<b>AMENDMENT OF SOLICITATION/MODIFICATION OF CONTRACT</b>			1. CONTRACT ID CODE		PAGE OF PAGES 1   6		
2. MODIFICATION NO.:  0007		3. EFFECTIVE DATE  NOV 10, 2004		4. REQUISITION/PURCHASE REQ. NO.  W81W3G-2035-7181		PROJECT NO. (If applicable)	
6. ISSUED BY Department of the Army Baltimore District, Corps of Engineers Contracting Division P.O. Box 1715 Baltimore MD 21203-1715		CODE CA31		7. ADMINISTERED BY: Contracting Division, Contracts Branch CENAB-CT-C 10 S. Howard ST. Room 7000 Baltimore, MD 21203-1715		CODE E1P0100	
8. NAME AND ADDRESS OF CONTRACTOR (No., street, county, State and ZIP Code)				(x)		9A. AMENDMENT OF SOLICITATION NO. W912DR-04-R-0062	
				X		9B. DATED (SEE ITEM 11) AUG 16, 2004	
						10A. MODIFICATION OF CONTRACT/ ORDER NO.	
						10B. DATED (SEE ITEM 13)	
CODE		FACILITY CODE

**GENERAL PURPOSE WAREHOUSE, BUILDING 732  
DEFENSE DISTRIBUTION CENTER/DISTRIBUTION DEPOT SUSQUEHANNA PENNSYLVANIA (DDC/DDSP),  
NEW CUMBERLAND, PENNSYLVANIA**

AMENDMENT NO. 0007 TO RFP W912DR-04-R-0062  
EFFECTIVE NOV 10, 2004

SKE-7

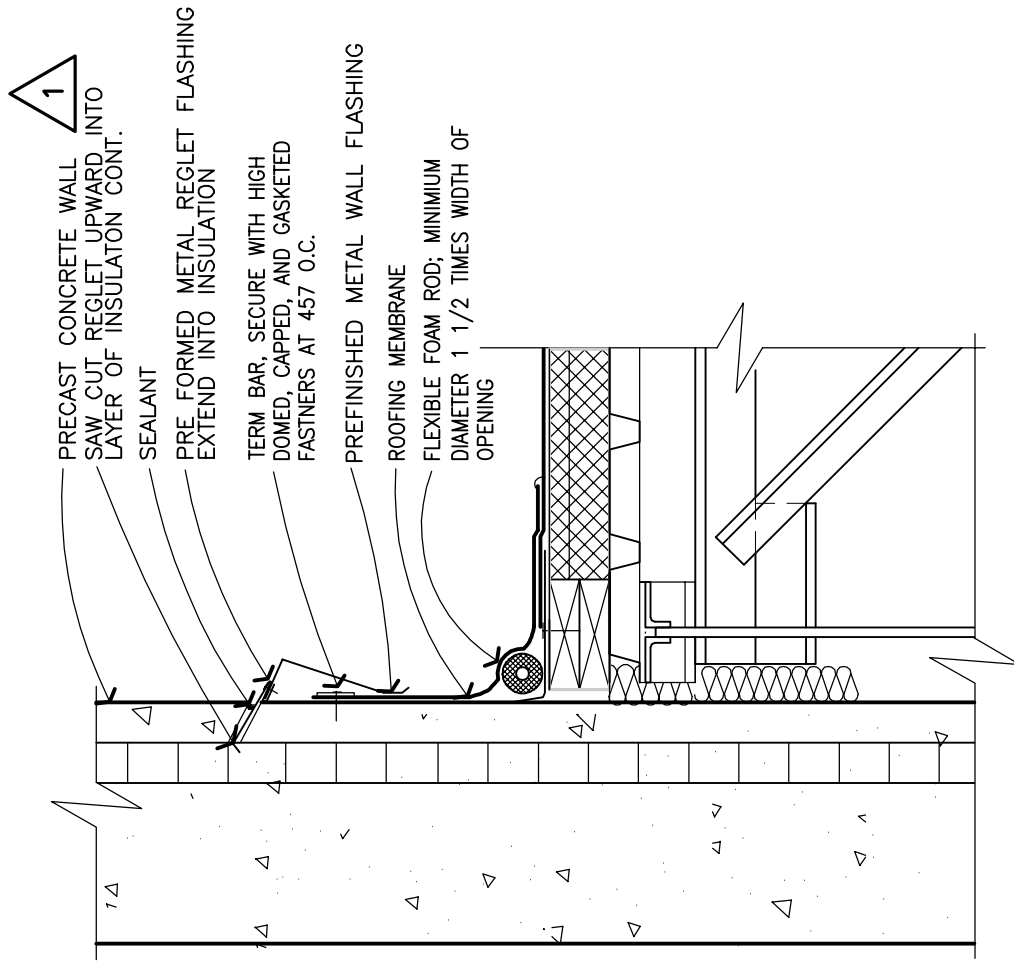
- 18) Sheet A4.1.1, Detail 4/A4.1.1: Delete detail in its entirety.
- 19) Sheet A5.1.0, Detail 8/A5.1.0: Revise this detail as shown on attached Sketch SKE-7, dated 10/15/04.

HIGH LIFT DOOR JAMB 8  
1:10 | A5.1.0

SKE-08

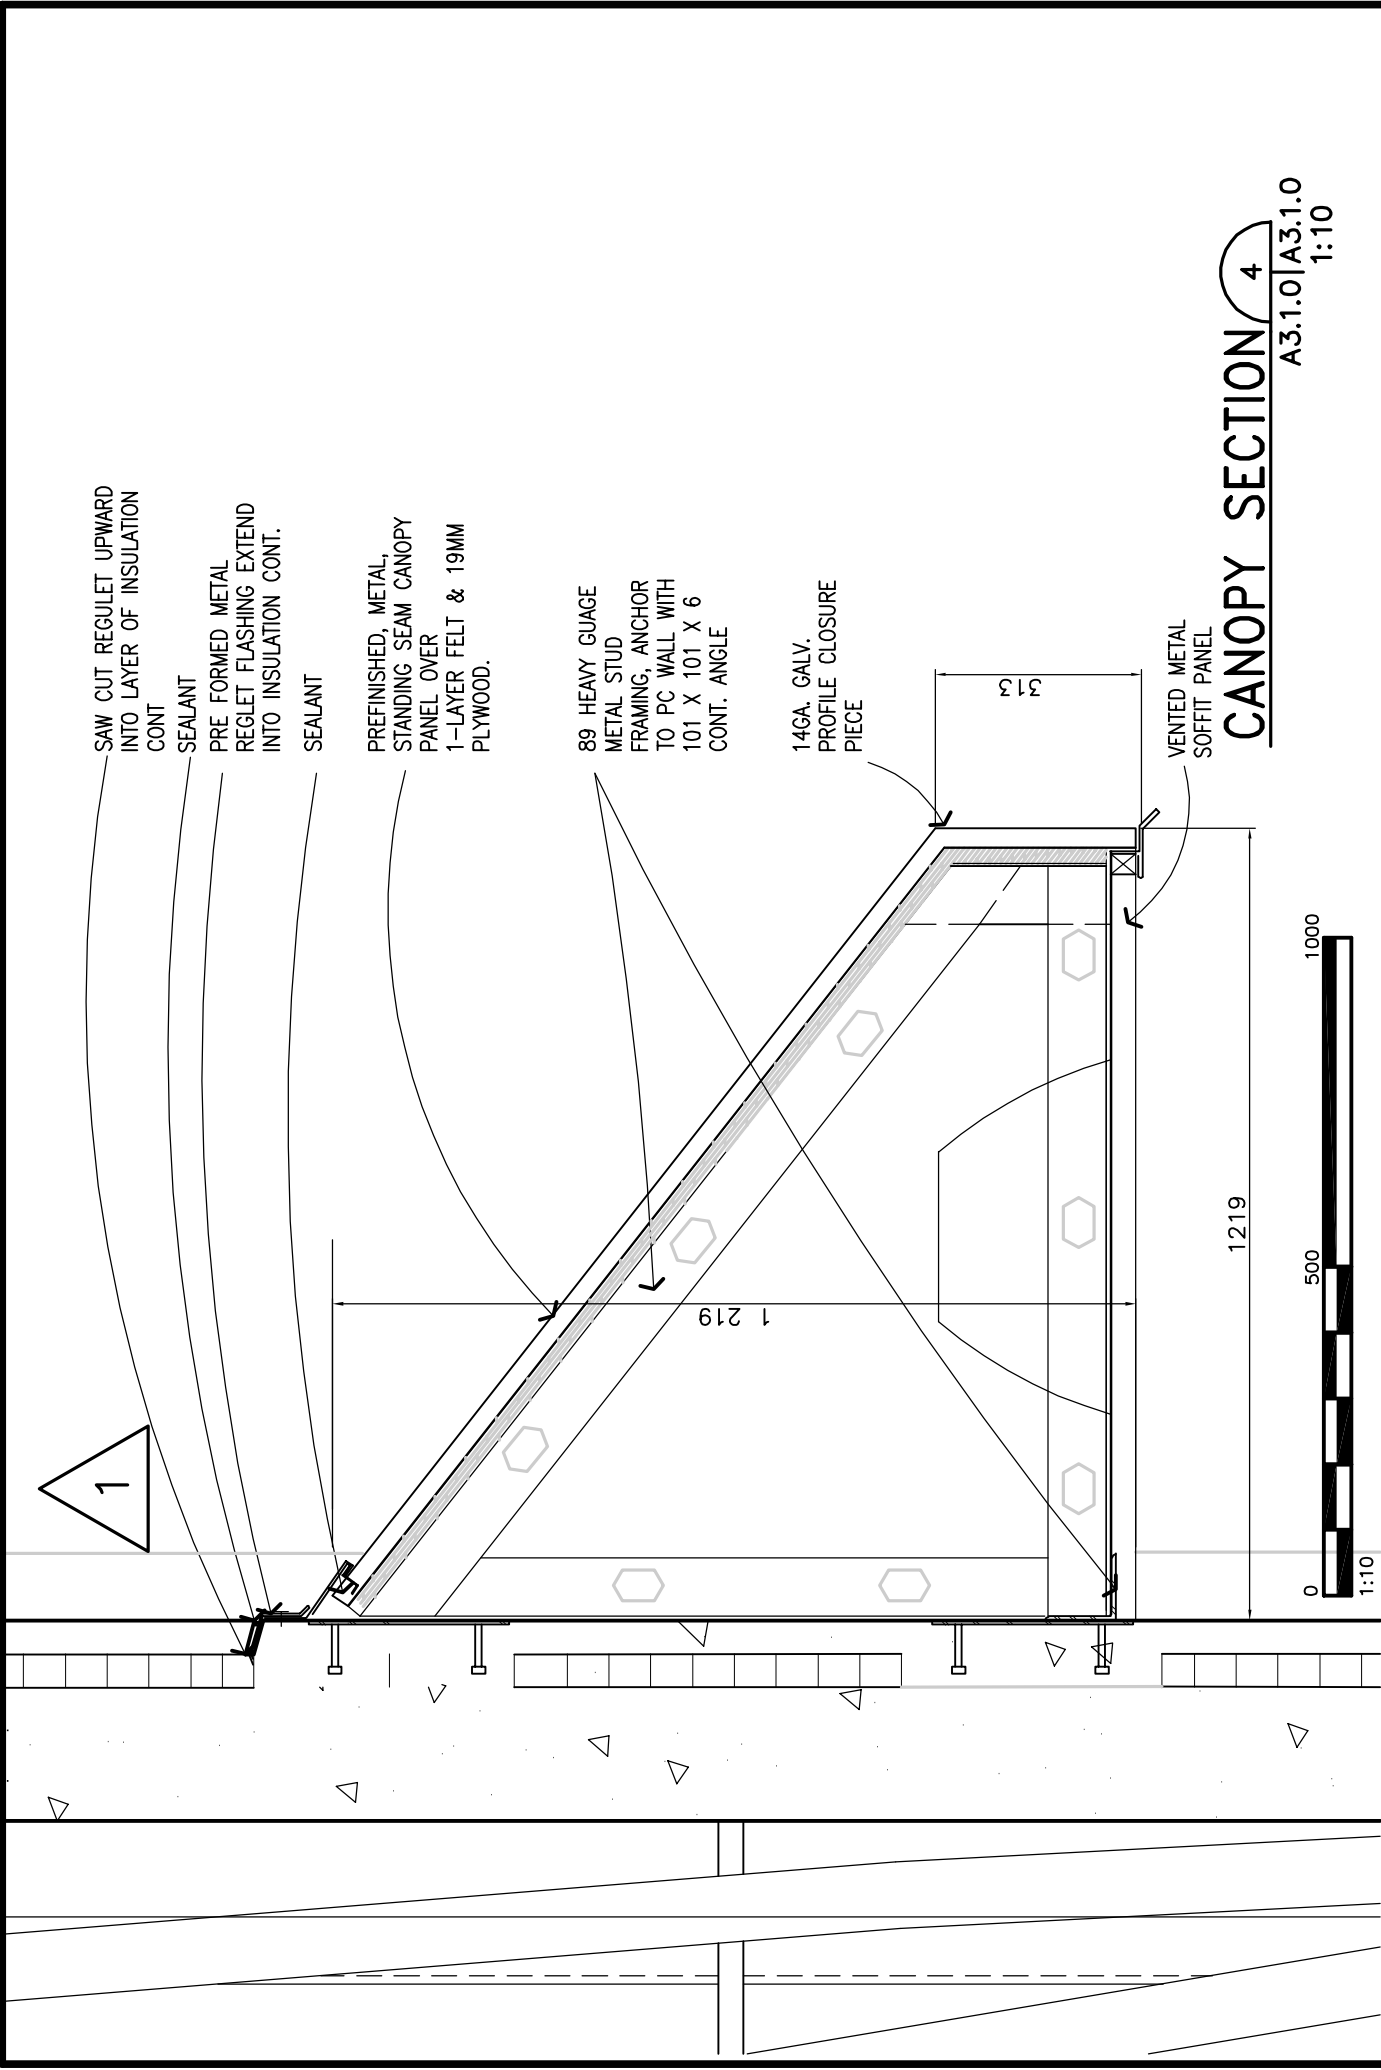
- 12) Sheet A3.1.0, Detail 4/A3.1.0: Revise this detail as shown on attached Sketch SKE-9, dated 10/15/04.
- 13) Sheet A1.3.0, Detail 7/A1.3.0: Revise this detail as shown on attached Sketch SKE-8, dated 10/15/04.

EXPANSION JOINT 7  
A1.3.1|A1.3.0  
1:10
